SUBJECT: Final Report on Work to Modify Magnolia Power Project with Additional Safety Platforms, Stairs and Ladders to Aid Maintenance Access to Plant Equipment

Subject: Corrections to Submitted Plans for Fabrication and Erection of Additional Safety Platforms for Magnolia Power Project

SUBJECT Magnolia Power Plant PC #BS0712001
164 W. Magnolia Blvd.

Response to Memorandum from Mr. Don Strand of Brandow & Johnston, Inc. to Mr. Calvin Chang at the Building Department, City of Burbank dated December 18, 2007.

GTG-3: PLAN VIEW

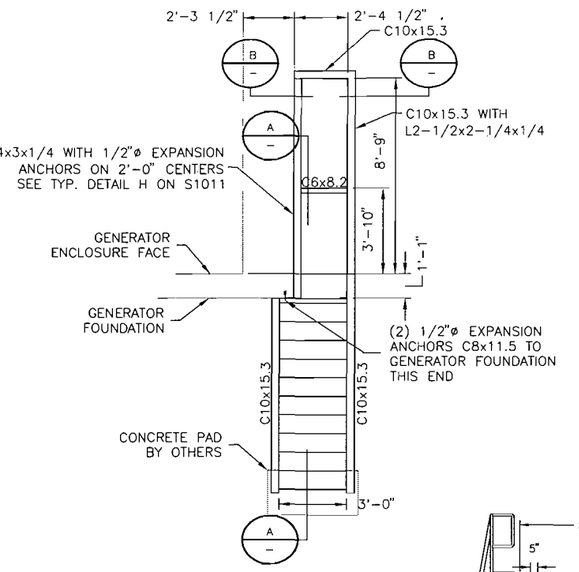
Comment: GTG-3 Plan – Who is to provide concrete pads (by others) and what size are these pads?

Comment: GTG-3 Section A – Change 1/S1011 to A/S1011.

Response: The concrete pads will be provided by BWP Craftsmen built per concrete pad design sketches as provided by Black & Veatch. (see attached sketches)

Response: B&V has made this revision on the drawing. (see attached drawings)

GTG-5: SECTION E-E

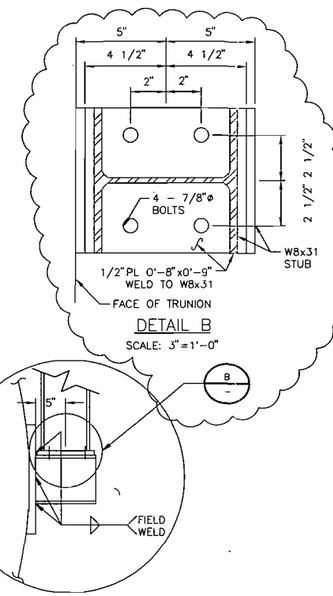
Comment: GTG-5 Section E – Provide connection detail of W8X31 beam to W8X31 column. Also verify adequacy of column to W8X31 stub welded to existing trunion plates.

Response: B&V has added a connection detail to the drawing. (see attached drawings) B&V has also provided a calculation to prove the adequacy of the weld to the trunion plates. (see attached calculations)

GLAND STEAM COND. VALVE ACCESS PLATFORM (GSC-1) PLAN

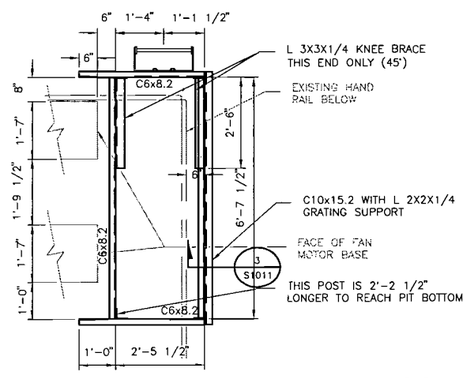
Comment: GSC-1 Plan – Provide section of C6x and L3x brace since no detail given for connection to existing.

Response: The 3X3X1/4 angle brace connects to the C6 and 4X4X1/4 angle post and does not attach to any existing steel.

ZLD PLATFORM ACCESS
SECTION LOOKING SOUTH

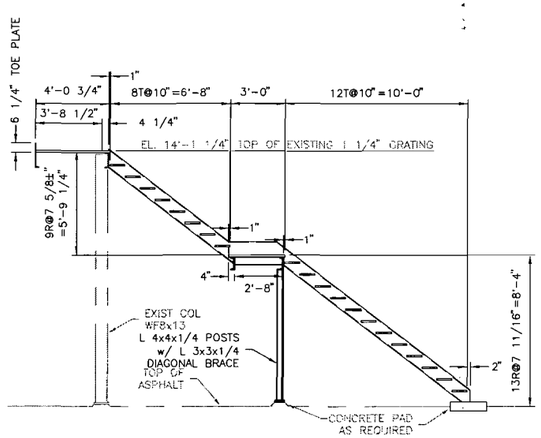
Comment: ZLD Platform Section looking South – Who provides pad (and size) "as required"?

Response: The concrete pads will be provided by BWP Craftsmen built per concrete pad design sketches as provided by Black & Veatch. (see attached sketches)

SECTION 1

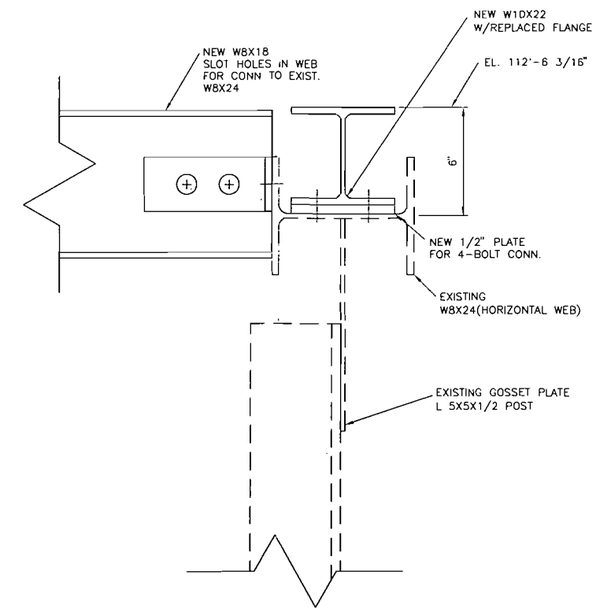
Comment: Section 1 – Verify stability and capacity for vertical load of existing gusset plate to the Lx5.

Response: B&V have performed a calculation to confirm this connection. (see attached calculations)

DETAIL A

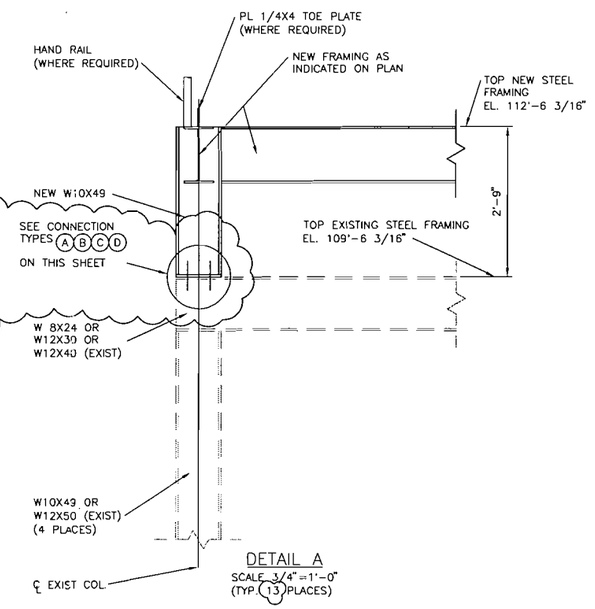
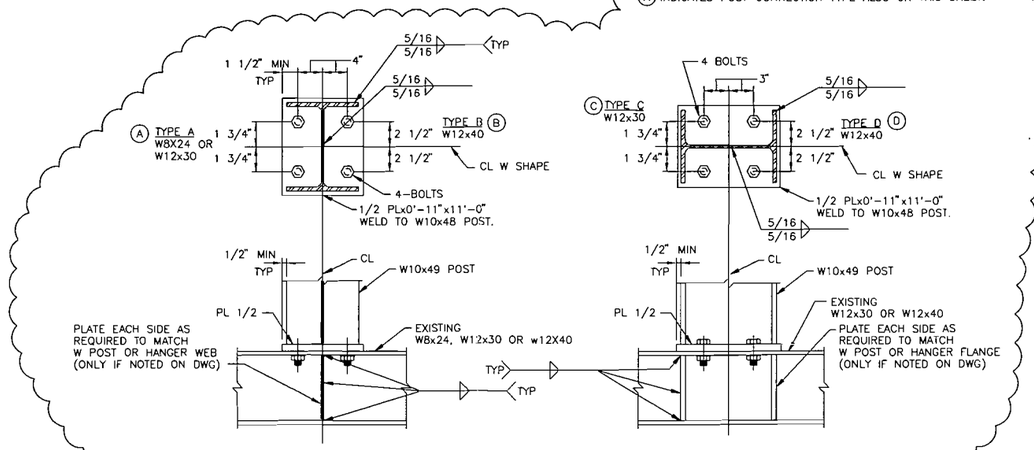
Comment: Detail A – Provide connections between beams and columns.

Response: B&V have added details Post Connection Details A, B, C, & D to this drawing, (see attached drawings)

TYPICAL STAIR RAIL DETAIL

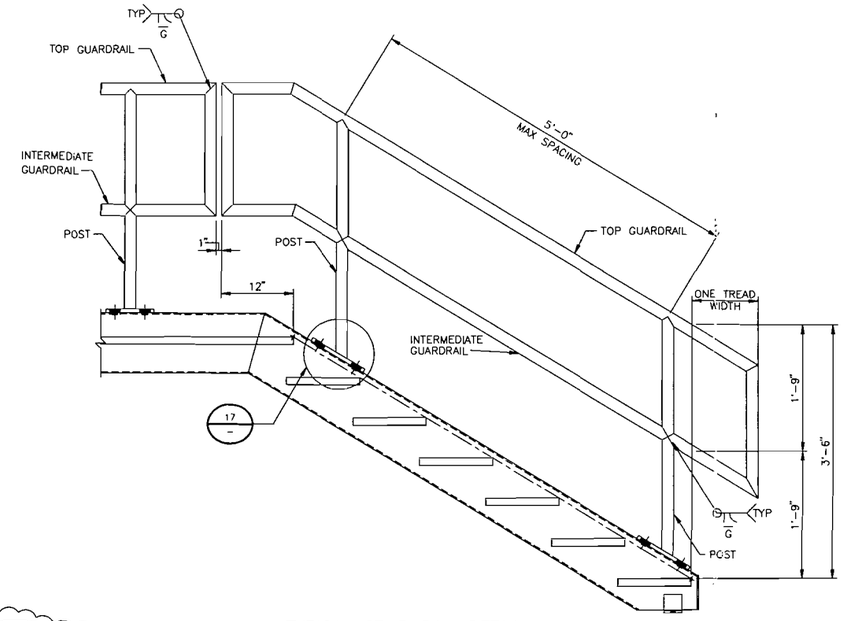
Comment: Typical Stair Rail – Spec. calls for 6' – 0" maximum spacing of posts. Also call out rail and post pipe size and verify.

Response: The 6' spacing called out in the specification is for horizontal applications. The intent of the detail on S1012 is for stairways where B&V uses a maximum of 5'. The rail and post sizes are specified in Article 5A.3 in the specification. These details are "Standards" and are used across many projects, By only calling out the sizes in the specification (which is always tailored to the project) you do not have to always change the details.

DETAIL 17

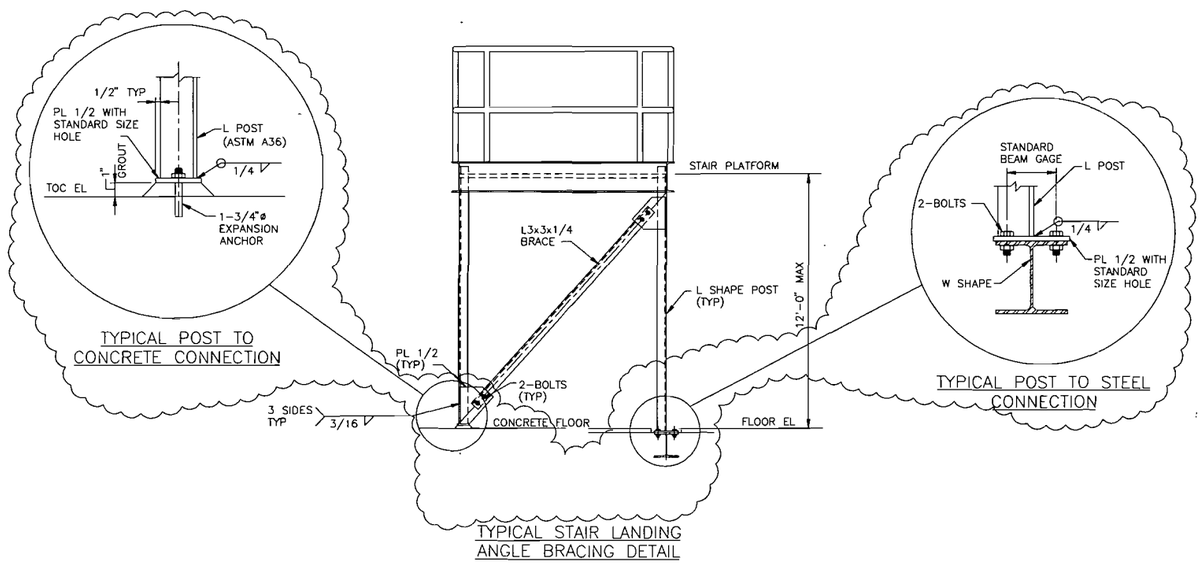
Comment: Detail 17 – ¾" bolt is maximum for C10.

Response: Details are "standard" and set up to cover various useages. In the case of this project the channel is a C10 and in accordance with AISC ¾ bolts are to be used. In order to clarify B&V has removed the 7/8" bolt call-out. (see attached drawings)

BYPASS VALVE ACCESS PLATFORM GRATING PLAN @ 601'-0" TOS

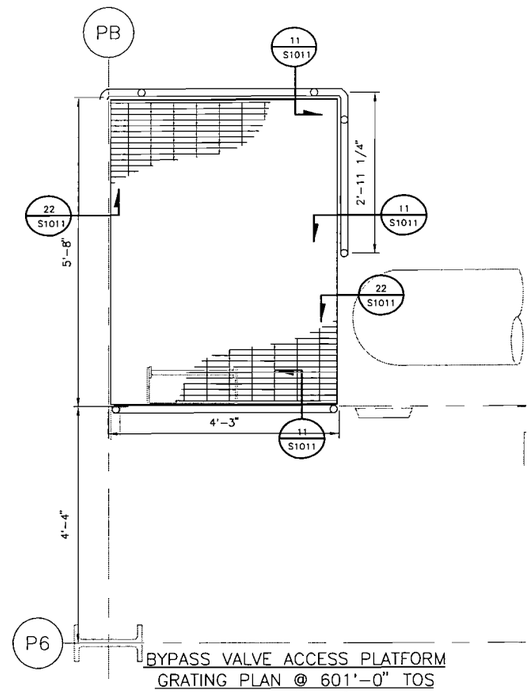
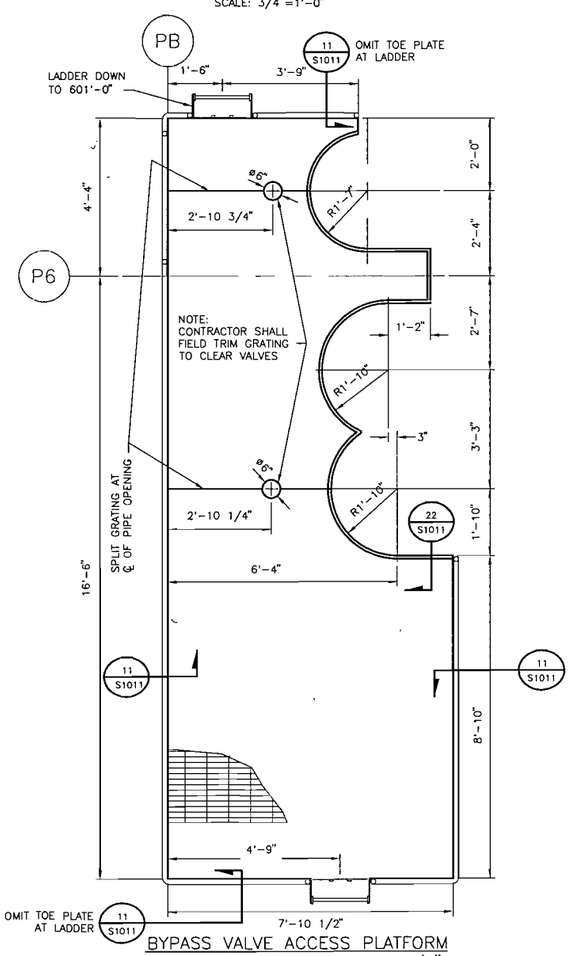
Comment: Bypass Valve Platform – Support framing of grating couldn't be found. At deep cut-out at P6, is there support of this grating.

Response: The support framing for this platform is shown on S1007.
